**Westside Middle School Addition & Renovation –  
Final Bid  
ADDENDUM NO. 1**

## ADDENDUM

**ADDENDUM NO.:** #01

**PROJECT:** Westside Middle School Cafeteria Addition

E2.0

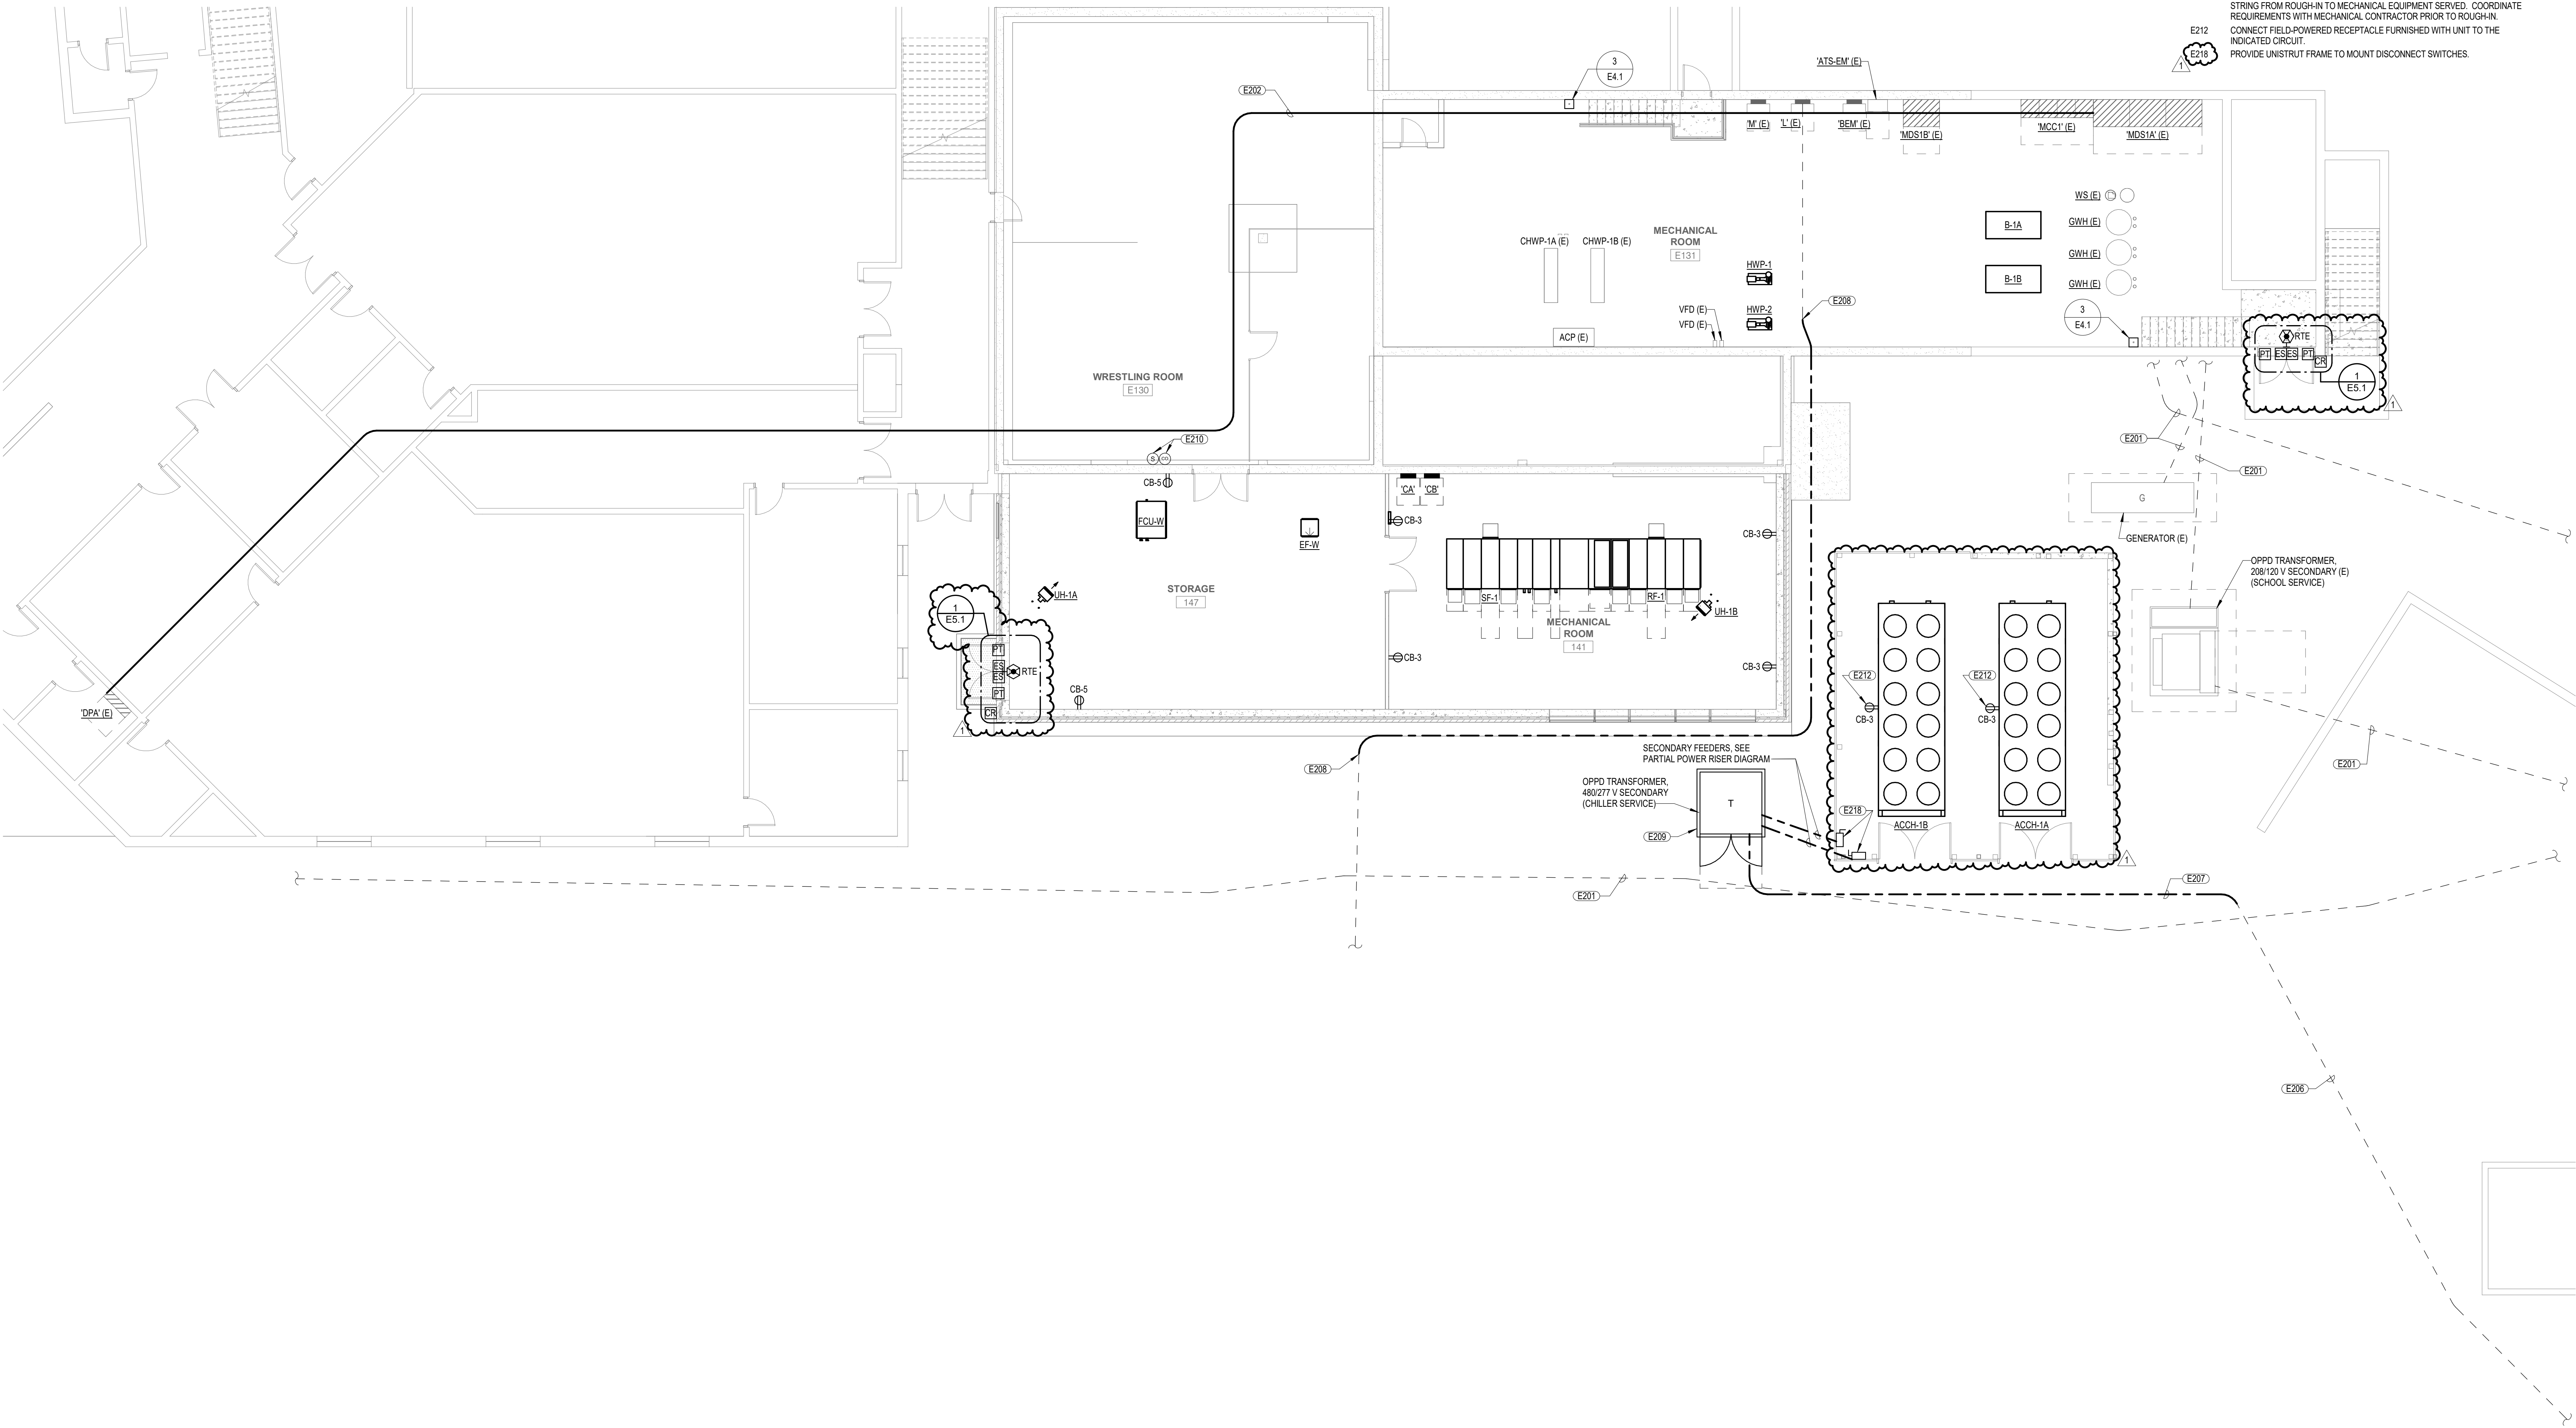
14. Sheet ED1.1 – FIRST FLOOR PLAN – ELECTRICAL DEMOLITION
  - a. Add note to reinstall existing special purpose receptacle in cafeteria in lieu of demolition.
15. Sheet E2.0 – LOWER LEVEL PLAN – POWER
  - a. Add access control rough-ins to exterior Storage 147 door.
  - b. Add access control rough-ins to exterior Mechanical Room E131 door.
  - c. Modify location of chillers and associated field-powered receptacles and disconnects.
  - d. Add Unistrut support for chiller disconnect switches.
16. Sheet E2.1 – FIRST FLOOR PLAN – POWER
  - a. Add reinstalled special purpose receptacle in cafeteria.
17. Sheet E4.1 – ELECTRICAL DETAILS
  - a. Add clarification that existing switchboard 'MDS1A' is Siemens SB3 on Partial Power Riser Diagram 7/E4.1.
18. Sheet E5.1 – ELECTRICAL SCHEDULES
  - a. Modify Access Control Rough-In Detail 1/E5.1 to also apply to locations mentioned above.
